Response to the comments of Transport Department (as at 30 June, 2026)

擬議臨時貨倉及露天存放建築材料連附屬設施及相關的填土工程(為期3年)

Response to the comments of District Lands Officer/North, Lands Department (as at 09 July, 2026)

Response to the comments of Commissioner for Transport, Transport
Department (as at 15 July, 2026)

圖號:
圖 12

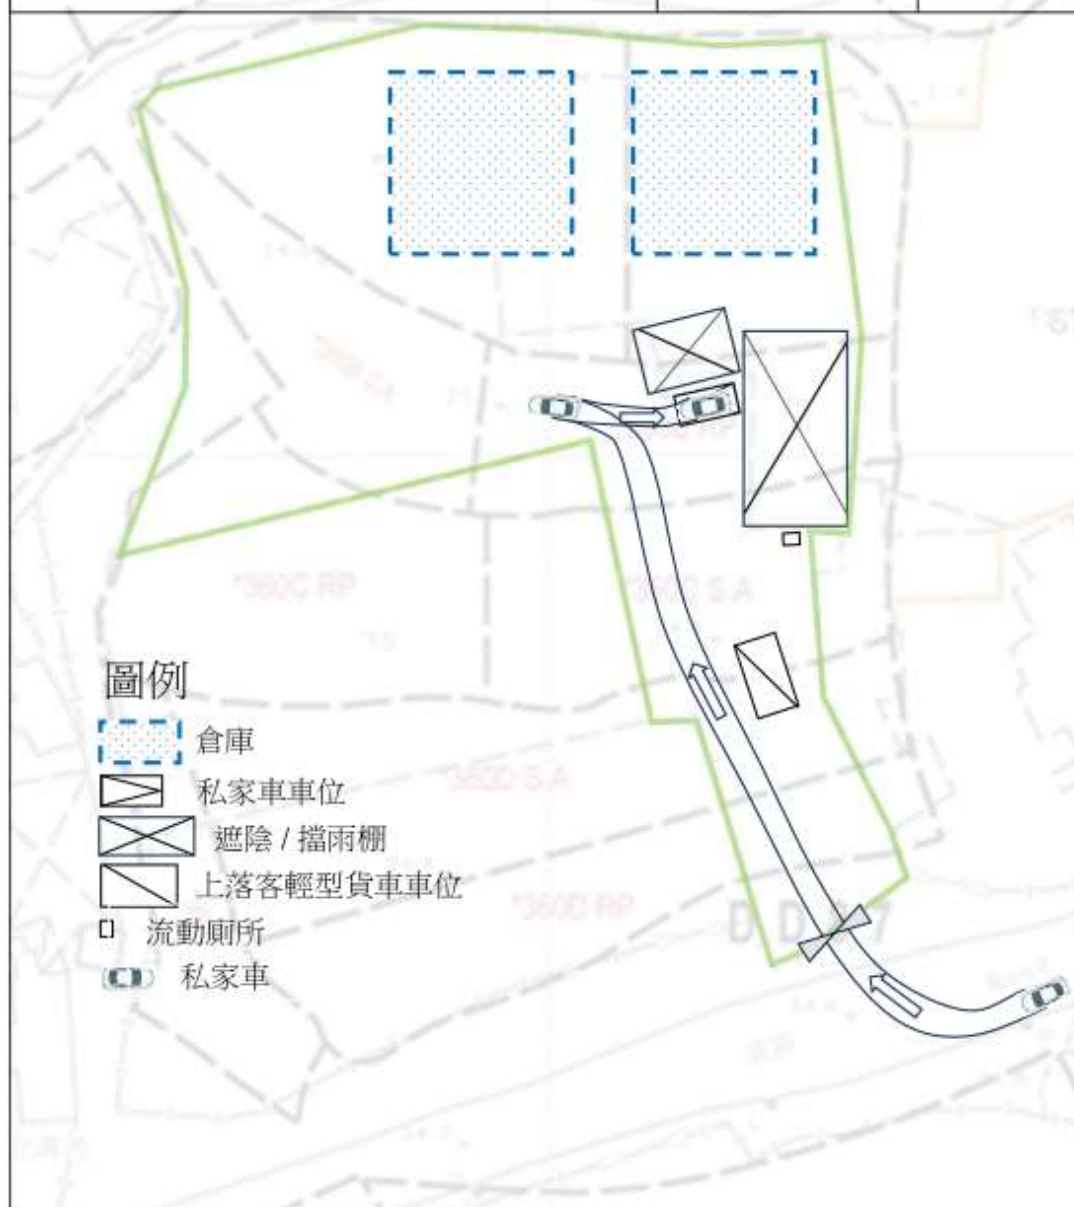
1. The applicant shall demonstrate the satisfactory maneuvering of the private car within the application site (the Site) and into/out of the parking, preferably using the swept path analysis:

知悉。有關私家車的車輛行車線分析圖已新增。見下圖 10, 11, 12, 13。

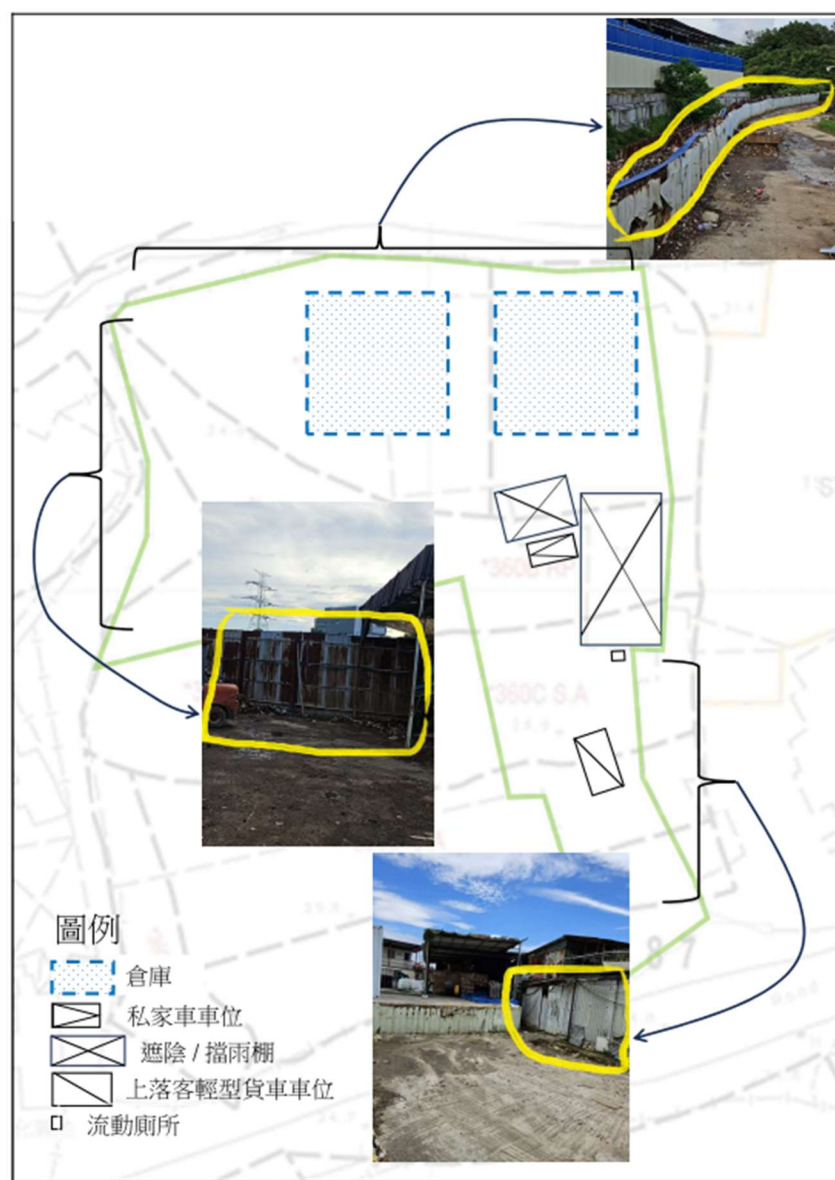
3. Please advise if any fencing will be erected along the site boundary on all sides. If so, please provide details on the material and height of the fencing.

基於安全，現時在場內周邊是有圍板設置的。高度約 1 米至 3 米不等，材料均為耐火、不助燃鐵板。大概位置及範圍可參考附圖。
